ASB-1031

## Service Bulletin

**Subject:** SMC-34 Distorted/muffled transmit audio

**Date:** July 20, 1993

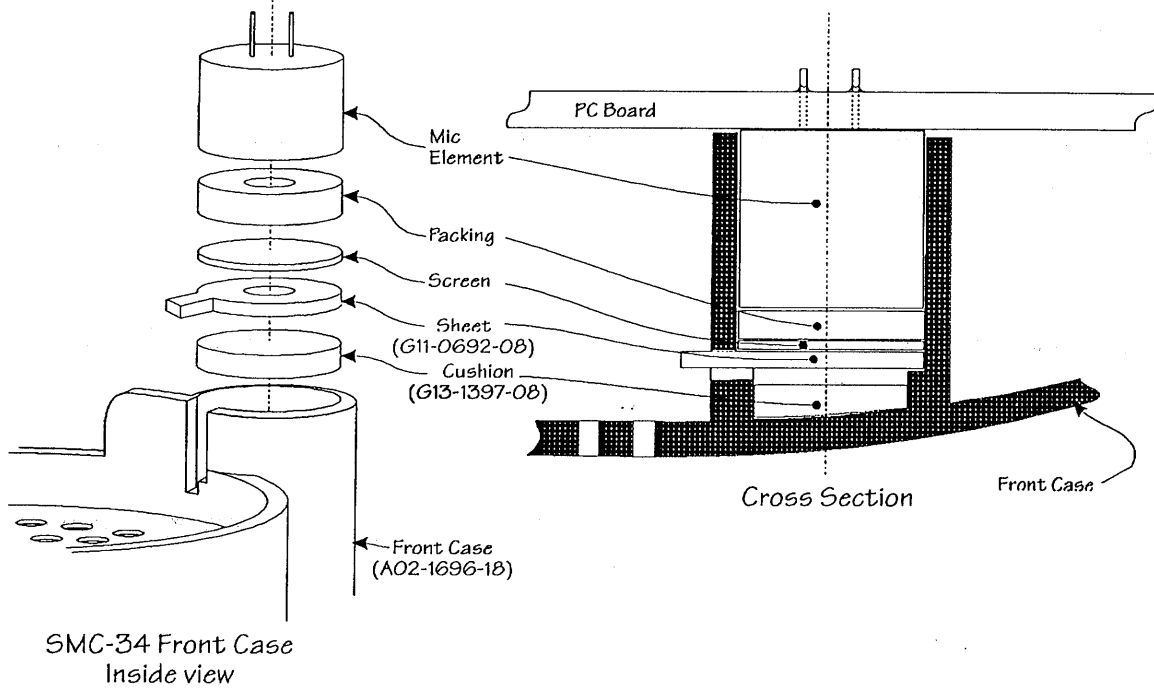
Replace the front case of the microphone, add a cushion inside the microphone well and change the plastic sheet inside the microphone well.

1. Remove the three small black Phillip's head screws from the rear of the speaker microphone.
2. Carefully remove the back cover. The "Lock Switch" lever and the PTT lever can now be removed.
3. Remove the volume control knob by pulling straight away from the case.
4. Remove the two small black Phillip's head screws that secure the PC Board assembly to the front case of the microphone. You can now gently lift the PC Board assembly straight up and away from the front case.
5. Remove the packing, screen, and sheet from the front case of the speaker microphone.
6. Insert the cushion, sheet, screen and backing as shown in the accompanying illustrations.
7. Reverse steps 1 - 4 to reassemble the unit. Note: Carefully remove the rubber gasket from the old front case and position it in the new front case groove before replacing the rear case
